AMENDMENT OF SOLICITATION/MODIFICATION OF CONTRACT			1. Contract Number	Page of Pages 1 1	
2. Amendment/Modification Number DCHA-2011-B-0145-003		3. Effective Date See Section 16C		4. Requisition/Purchase Request No.

5. Solicitation Caption Install New Playground and Walking Track at Dakota Park	
6. Issued By: Department of Real Estate Services Contracting and Procurement Division 2000 14th Street N.W., Suite 500 Washington, D.C. 20009			Code 03B	7. Administered By (If other than line 6) Department of Real Estate Services Contracting and Procurement Division 2000 14th Street N.W., Suite 500 Washington, D.C. 20009

**ATTACHMENT 1 TO AMENDMENT #DCHA-2011-B-0145-003
TO SOLICITATION NO. DCHA-2011-B-0145**

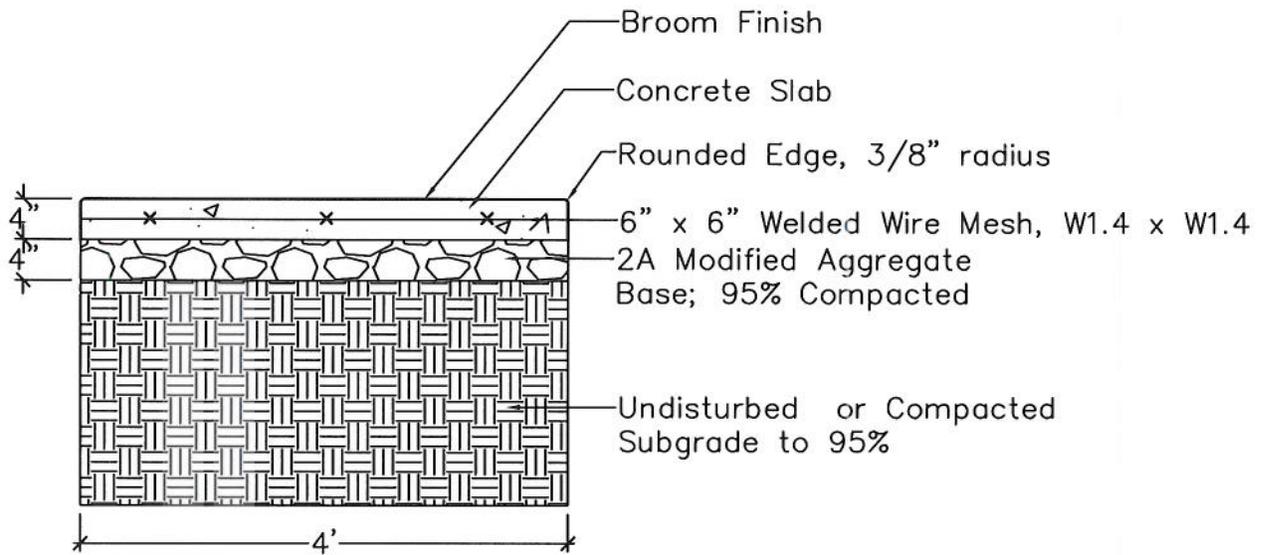
QUESTION #3

Can more information be provided on C.2.4.8: it was mentioned at the pre-bid meeting that concrete would no longer be used.

ANSWER #3

The Contractor shall use asphalt instead of concrete for the walkway – 2" compacted asphalt on top of 4" compacted stone subgrade.
